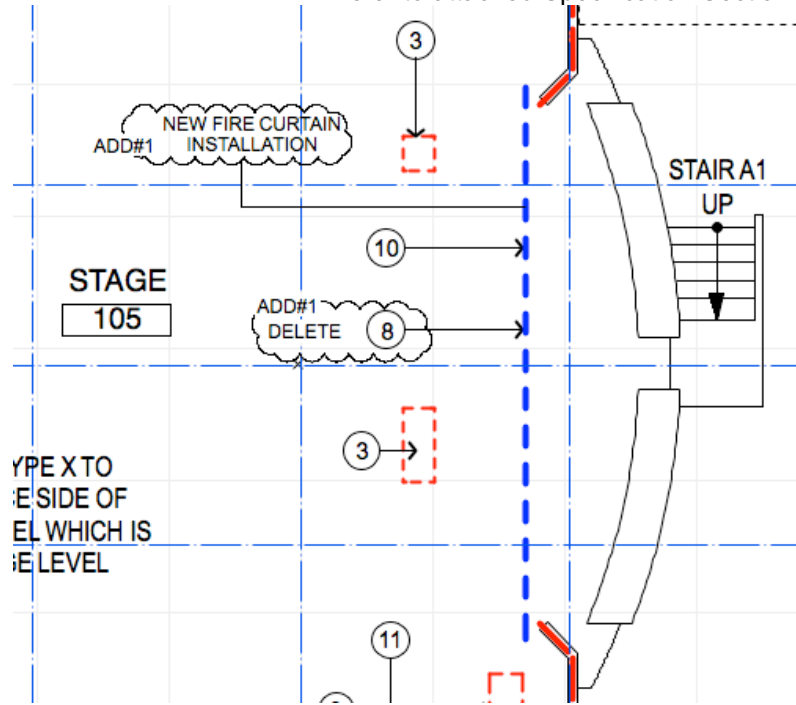
Partial plan of A1, Delete, Item 8, Deluge sprinkler system,
 Add, New Fire Curtain at location shown
 refer to attached Specification Section 11 61 00

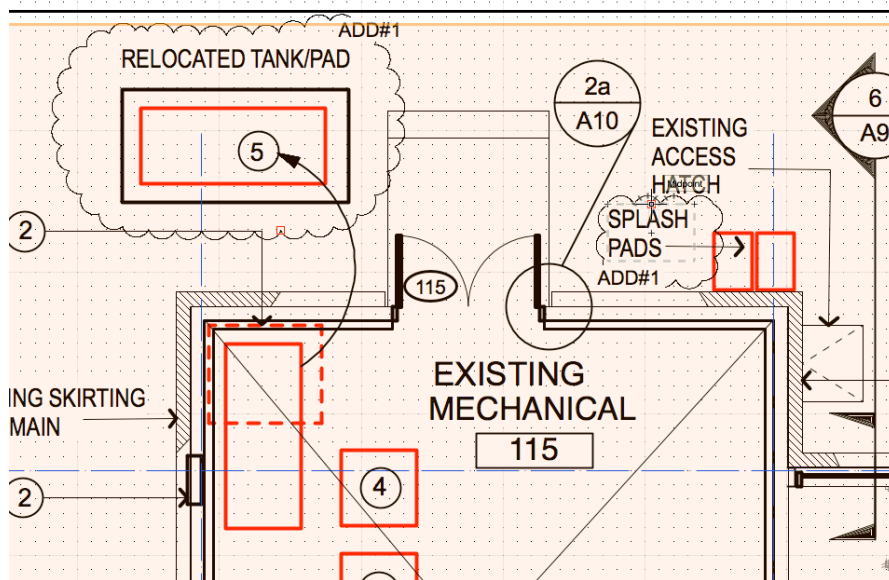
Partial plan of A1, Relocate, Tank and Pad from the Interior of Mechanical 115
 the exterior location and highlighted Splash pad locations.

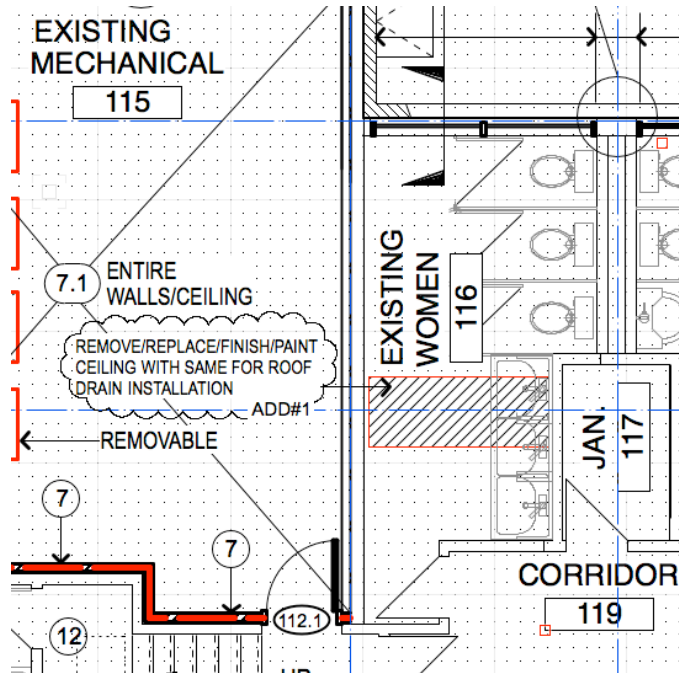
Partial plan of A1, Add, the removal/replacement/finishing and painting of the ceiling material in WOMEN 116 to access overhead mechanical drain installation.

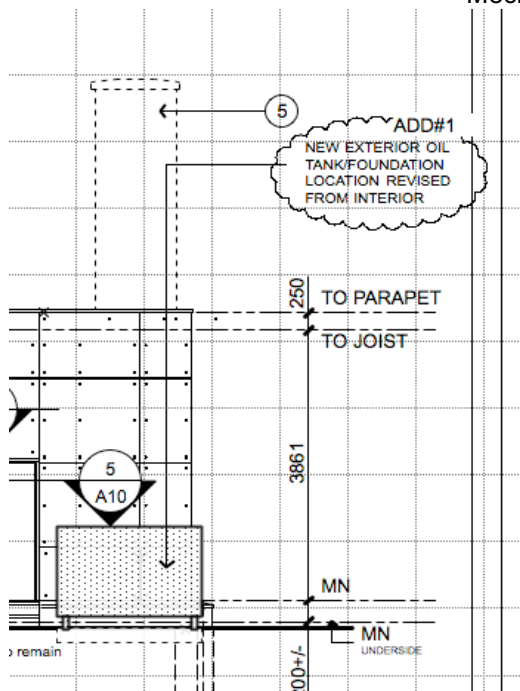
Partial plan of A5, East Elevation 1/A5, Relocate, tank and pad from interior Mechanical room to Exterior as shown.

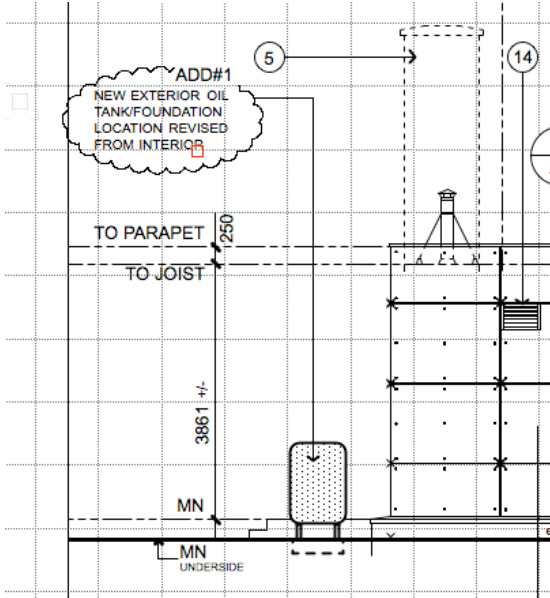
Partial plan of A5, North Elevation 2/A5, Relocate, tank and pad from interior Mechanical room to Exterior as shown.

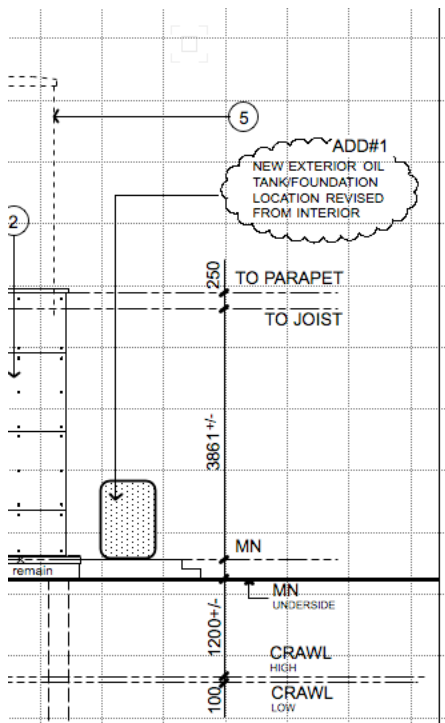
Partial plan of A6, South Elevation 2/A6, Relocate, tank and pad from interior Mechanical room to Exterior as shown.
